Comprehensive Plan: Alder Future Land Use Map Comments

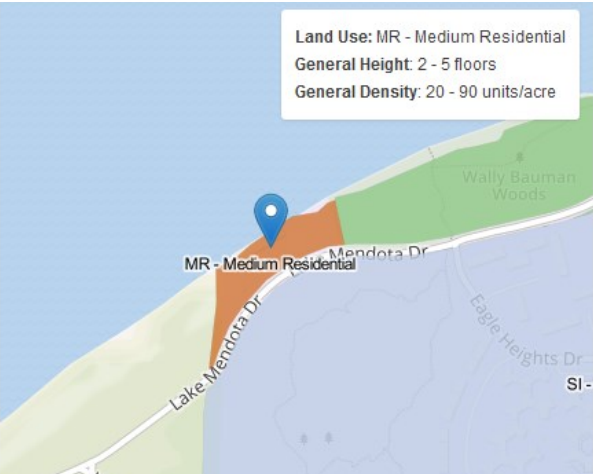
4. Should The Cove condominiums be shown as HR instead of MR? 	The Cove, located at 3100 Lake Mendota Drive (along the Lake Mendota shoreline and the Shorewood Hills border), is currently shown as MR. The building is nine stories when viewed from the lake side and six floors when viewed from the street.	HR would more accurately represent the current land use. Redevelopment of this site is unlikely over the next 20 years. However, if the site were to redevelop, staff feels that the MR designation is most appropriate, given the isolated nature of the site and the surrounding context. An HR designation could lead to a building that is far more substantial than what is there now, potentially standing out amongst far lower intensity surroundings. MR acknowledges the general building form that is there now while allowing for a potential future use that can reasonably fit in with the surrounding context.

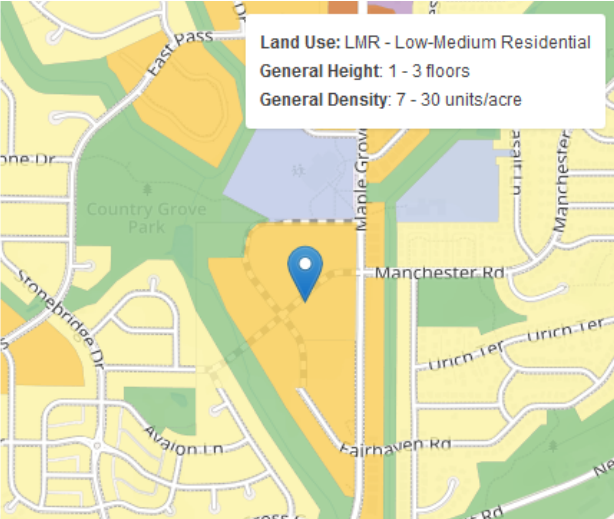
Alder Question/Comment/ Recommendation	Staff Discussion	Staff Recommendation
5. LMR should be considered for the First Settlement neighborhood.	Most of the buildings in this the area designated for residential (see red line on isometric air photo below on the left) are in the 1-3 floor range, and the First Settlement Historic District (see red outline on FLU map below on the right). The ordinance for the District states that “New principal structures shall be similar in height to the structures directly adjacent to each side. If the structures directly adjacent to each side are different in height, the new structure shall be of a height compatible with the structures within two hundred (200) feet of the proposed structure” (see sec. 41.26(4)(a)). The Downtown Plan recommends a maximum building height of three floors for much of this area (see	While 2-3 floors does fit within the MR category, the LMR category is more appropriate for the residential areas mapped for up to three floors in the Comprehensive Plan. Other areas mapped for residential, specifically MG&E’s parking lot along S. Blair and the southern half of the Brayton Lot, should remain MR.

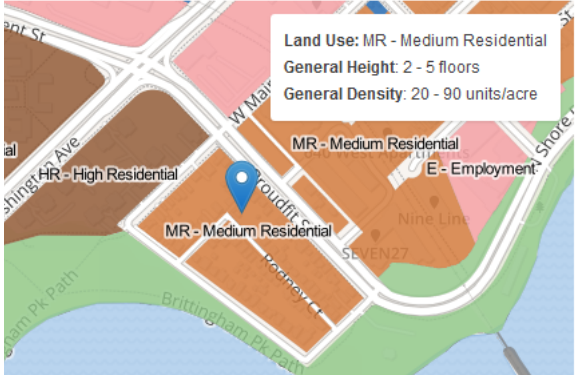
Alder Question/Comment/Recommendation	Staff Discussion	Staff Recommendation
6. Add a map note to the Schmitt Farm property to specify that the intensity of development should be the lowest by Badger Mill Creek and highest along Maple Grove Road. 	This area was changed from MDR in 2006 to LMR in 2018. The Cross Country Neighborhood Development Plan specifies medium density residential at “densities averaging 16 units per acre.”	Staff feels it would be appropriate to provide further detail through editing the map itself, rather than adding a map note. The edit could show LR along the Badger Mill Creek greenway, LMR in the middle of the property, and MR fronting Maple Grove Drive (in fact, the Copper Creek Apartments, which are along Maple Grove slightly north of Fairhaven Road, are more appropriate to the MR category).

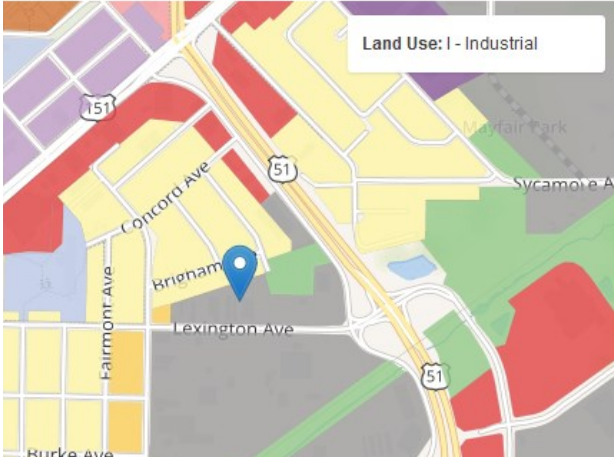
Alder Question/Comment/Recommendation	Staff Discussion	Staff Recommendation
8. The Brittingham Place area should be changed to LMR. 	While current development in this area is small-lot single family, this area was changed from LDR in the 2006 Plan to MR in this Plan to allow for redevelopment of old housing stock that is intermittently run-down, with some houses that have foundations that are sinking.	The Triangle Monona Bay Neighborhood Plan (TMBNP) process is ongoing, and may have draft recommendations prior to City Council action on the Comprehensive Plan. Staff recommends waiting until that process is further along before making any edits that may need to be changed again, pending further TMBNP input.

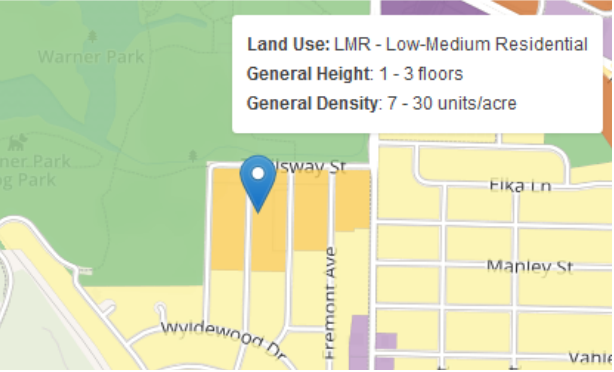
Alder Question/Comment/Recommendation	Staff Discussion	Staff Recommendation
11. Should the Brentwood area be changed back to MR from LMR to allow for future redevelopment in a cohesive manner? Current fractured ownership creates problems. 	This area had been MR in the 2006 plan, but was reclassified as LMR with this update. It is characterized primarily by 4-8 unit apartment buildings on small lots (there is also one 16-unit building and one 24-unit building). With the revisions of the residential categories, the current mixture of development most appropriately fits within LMR. Because the Northport-Warner Park-Sherman Neighborhood Plan does not show a redevelopment concept for this area (see page I-6), staff mapped the area with a land use category that best matches the current land use.	Discuss whether the area should be changed back to MR to allow for future redevelopment on a larger scale.

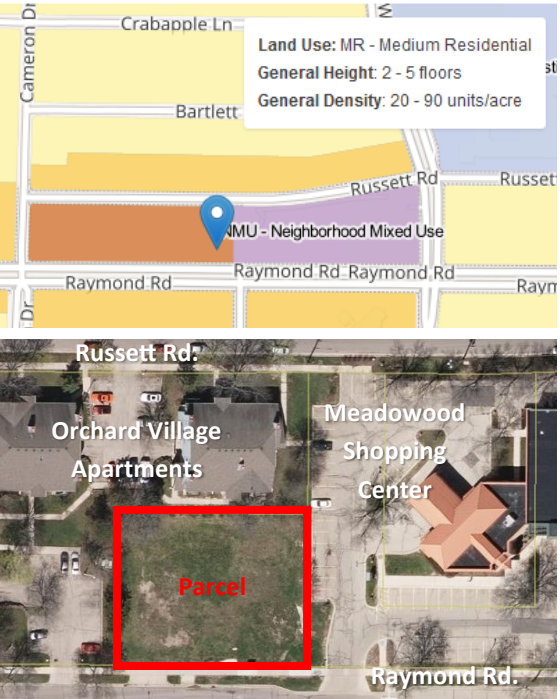
Alder Question/Comment/Recommendation	Staff Discussion	Staff Recommendation
13. A change from LR to LMR should be considered for portions of the Theresa Terrace/Bettys Lane area to allow for future flexibility for redevelopment and CDA projects. 	The area outlined in red at left is comprised entirely of duplexes, other than the Theresa Terrace Neighborhood Center. Because this area was mapped as LDR in 2006 and duplexes fit within the LR category in this 2018 update, the FLU map was not changed. The CDA currently owns two duplexes on Theresa Terrace (red dots on map). The potential exists for additional CDA property acquisition and redevelopment into townhomes, which more appropriately fits in the LMR category. The area is currently zoned SR-C3, which allows for single-family and duplex dwellings. Any townhome or multifamily redevelopment proposal would require rezoning of the property, necessitating a public hearing.	Discuss whether to change the designation within all or part of the area outlined from LR to LMR.
